CONSUMERS POWER COMPANY
MIDLAND ENERGY CENTER

ITEM/HOLD POINT NOTIFICATION FORM

MIDLAND NUCLEAR PLANT J.O. NO. 14509

Midland Plant Units 1 & 2
Bechtel Job 7220
STONE & WEBSTER OVERVIEW
ITEM NO. 072
BCCC-9287

Number NDE-PQ-RT-200, Rev. 1

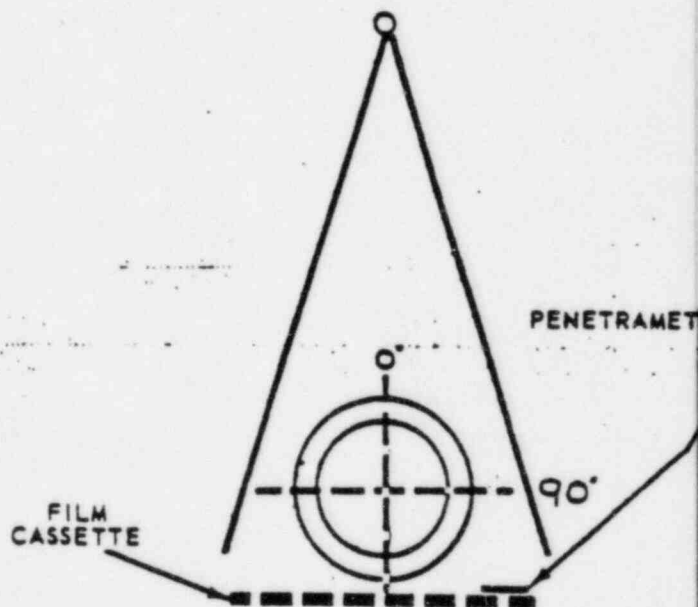
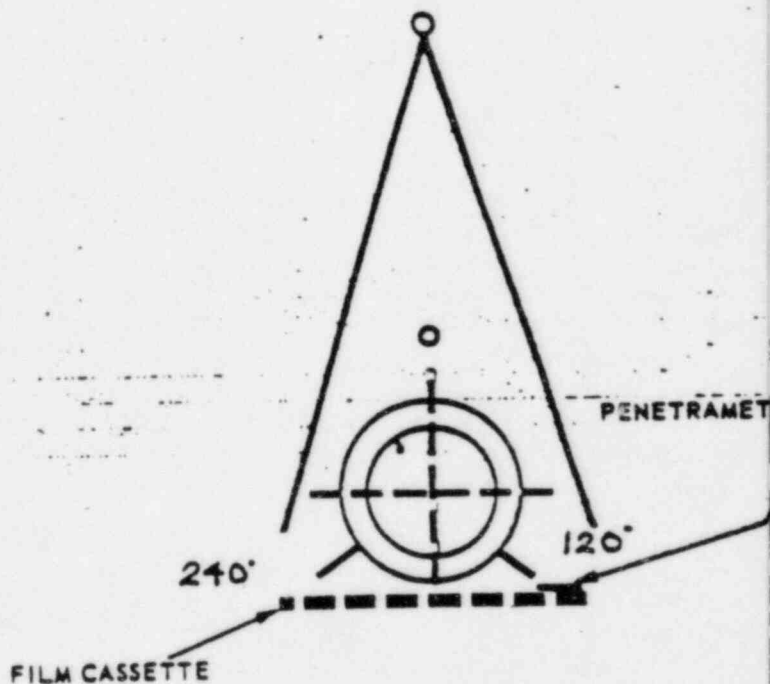
- A) Procedure NDE PQ-RT - 200 Δ consist of 3 pages
Page 1 of 3 reads: NDE-PQ-RT-200 Page 1 of 3 Revision 1
Page 2 of 3 reads: 9T-RT-200 Page 2 of 3 No Revision specified
Page 3 of 3 reads: 9T-RT-200 Page 3 of 3 No Revision specified
- B) Procedure NDE-PQ-RT-201 Δ consist of 3 pages
Pages 2 of 3 and 3 of 3 lack procedure number and revision
- C) Procedure NDE-PQ-RT-202 Δ consist of two pages
Pages 1 & 2 lack page number

Procedure NDE-PQ-RT-200 Revision 1, Page 2 of 3 and Page 3 of 3, have been annotated with PQ-RT-200 Revision 1.
